**City of Calgary  
LRT Crossing Safety Review  
Final Report**

2019-05-28	0	Draft	D. Hein	A. Hamel	D. Hein
<b>Date</b>	<b>Rev.</b>	<b>Status</b>	<b>Prepared By</b>	<b>Checked By</b>	<b>Approved By</b>
<b>HATCH</b>

**Figure 8-8 7 Ave at 4 St SE Pedestrian Crossing**

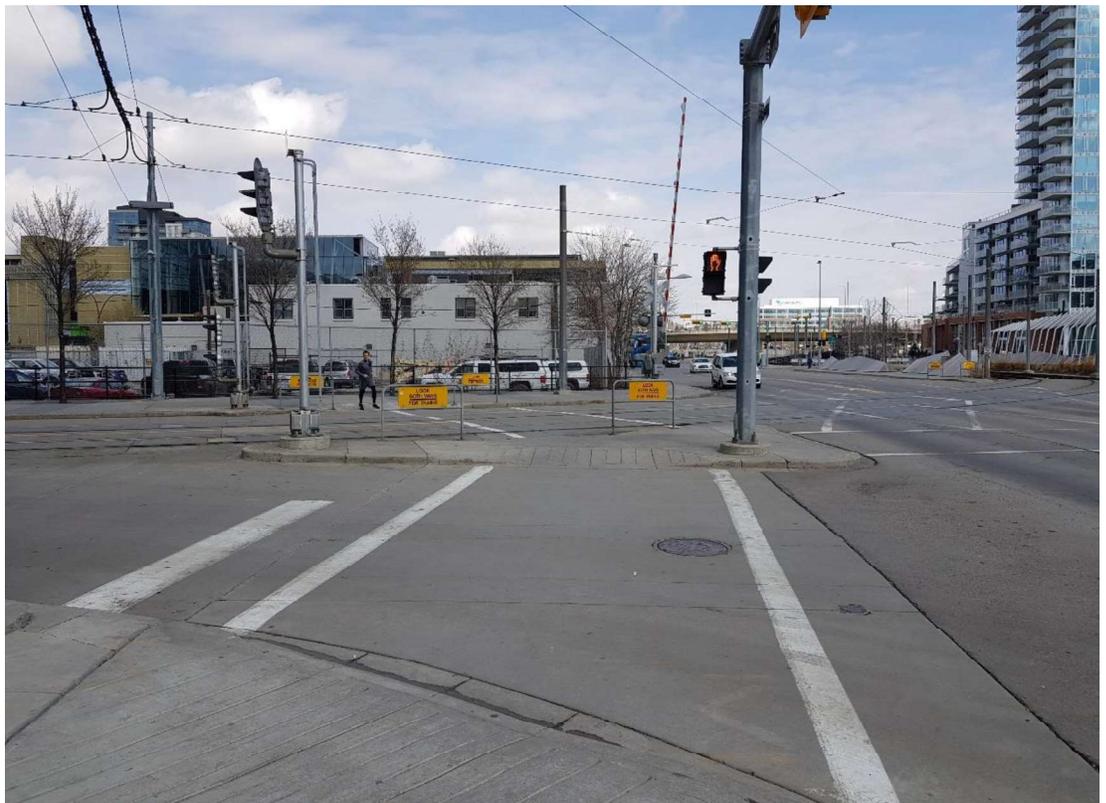
While looking at the approaches for the 3 St SE crossing, it was noticed that there is a pedestrian crossing located just west of 4th Street East that only has some channelization; there are no pedestrian signals or crossing warning signals provided. The adjacent road crossing has flashing lights with bell and gates and the pedestrian crossing on the east side of the road has bedsteads. We recommend that this pedestrian crossing be assessed and warning devices added as appropriate.

This issue has also been identified by Calgary Transit and Calgary Roads. The addition of flashing lights with pedestrian automatic gates, bells and second train warning signs is under review. The addition of cantilevered flashing light signals and bedstead barriers is currently being considered as a nearer term improvement.

**Figure 10-5 7 Ave at 7 St LRT Signage (Google)**

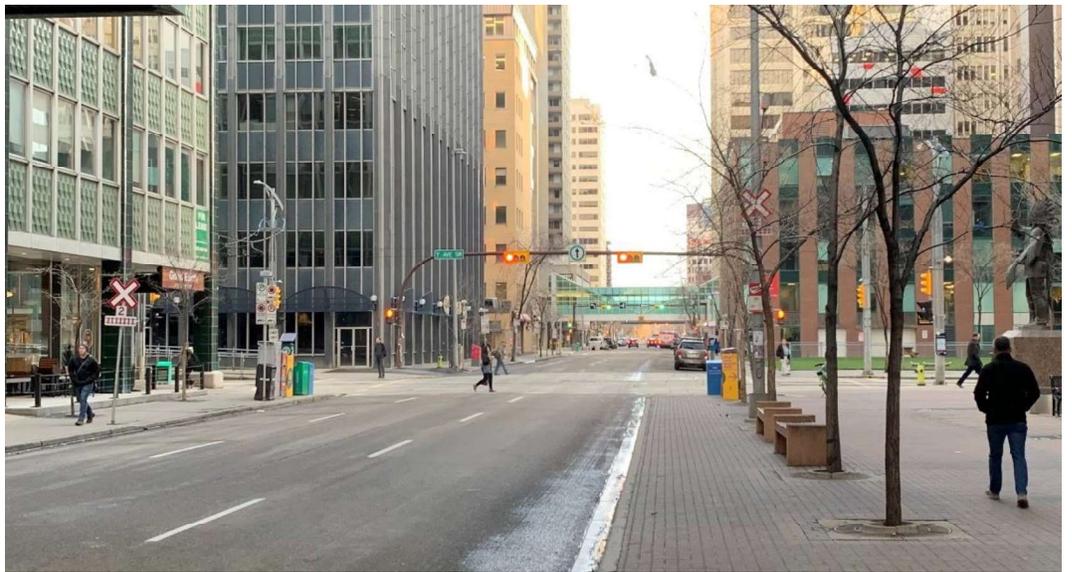
The LRT crossing signage near 7 Avenue is inconsistent (both in terms of the signs employed and placement) and should be standardized. Signage is missing for the cycle tracks in one direction (opposing direction to road traffic). Calgary Transit and Calgary Roads have conducted a review of signage for the LRT system in downtown and have developed a plan to address this issue.

**Figure 11-5 Emergency Notification Sign**

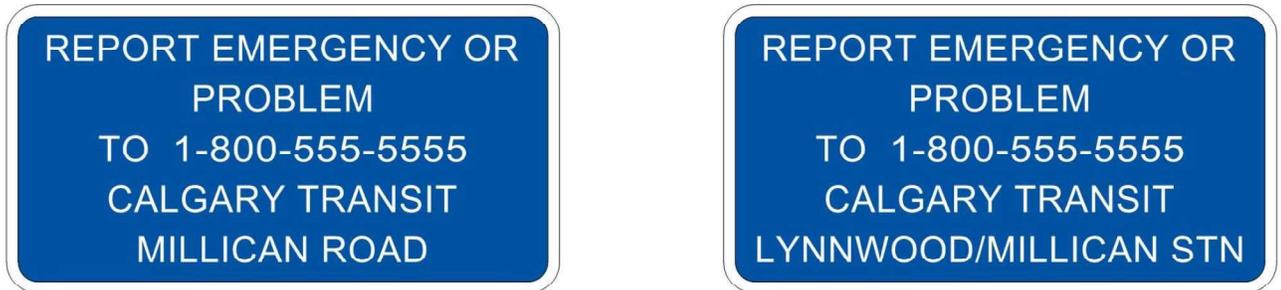
Emergency notification signs should conform to Figure 11-5.
